**Westmeath County Council Local Authority Development - File Ref. LA(A) – 4 -2023**

**Outdoor Recreation Infrastructure Scheme (ORIS) for Carn Park Link Trail at Baylin, Co. Westmeath.**

**Planning Report in Accordance with Section 179 of the Planning and Development Act 2000 (as amended) and Part 8 of the Planning and Development Regulations 2001 (as amended)**

Figure 5 – Revised Boardwalk Route

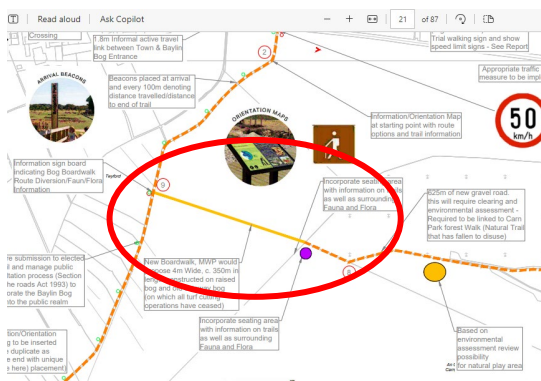
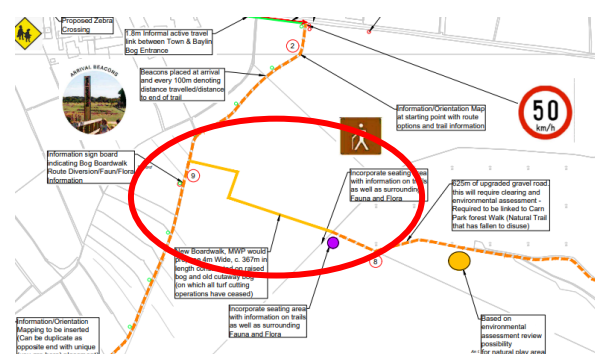
The submission states that the Department has safety concerns about the location of the proposed boardwalk owing to bog slumping. Attention is drawn to a scientific paper which it is recommended should be considered regarding the location of the boardwalk in the context of stability and safety of potential users.

The Department’s submission acknowledges that the updated reports state that the amended location of the bog boardwalk is a measure to avoid areas where cell bunding is proposed and this is welcomed. The report, however, considers that the proposed bog boardwalk element of the proposed project is premature as it may not be compatible with the wetter conditions expected by way of post rehabilitation works. In addition, it is suggested that the updated reports do not address any potential conflicts for machine access to carry out the necessary NPWS rehabilitation works.

Concerns are set out with respect to the conclusion of the updated AA Screening Report. The Department considers that the boardwalk would cover an area of bog and “overtime a lack of light would probably destroy the Qualifying Interests of vegetation underneath and therefore consider the conclusion is incomplete as cannot conclude there will be no adverse impact on the conservation objectives for the site”.

Concerns are also raised in terms of the impacts of potential face bank de-stabilization from driving wooden posts in the area with clarification sought in terms of the separation distance of the boardwalk from the slumping area.

In response to concerns raised by the Department of Housing, Local Government and Heritage in relation to proposed bunding, the proposed boardwalk has been amended to consider the locations of rehabilitation works on the bog and the amended route avoids interference with the drains on the cut-over and high bog. This realignment extended from the original 350m to 367m in total length, see Figure 5 below. The revised route of the proposed boardwalk is between two areas of slumping. The edge of the area of slumping to the south is 50m from the proposed boardwalk, while the edge of the area of slumping to the north is 100m away. Amended design includes the bordering of the gravel trail, providing a finished edge which will also have the effect of protecting the drain adjacent to the trail.

The revised route of the proposed boardwalk is between two areas of slumping. The edge of the area of slumping to the south is 50m from the proposed boardwalk, while the edge of the area of slumping to the north is 100m away. These separation distances are deemed to be satisfactory and are the maximum that can be achieved, while staying within the assessed corridor for the boardwalk. As stated in the previous point, the installation of the boardwalk will increase the stability of the bog in the immediate vicinity of the boardwalk.

It is recommended that the development should proceed in accordance with the details submitted, save for the amendments outlined under the revised response (including revised boardwalk location indicated on Drawing Number: 23784 MWP ZZ ZZ DR C 0001). The development to be carried out in line with the findings of the EclA and that pre-development archaeological testing be carried out and completed by a suitably qualified and licensed archaeologist prior to the commencement of development. The proposed boardwalk to be installed at a minimum of 1m above the bog surface.
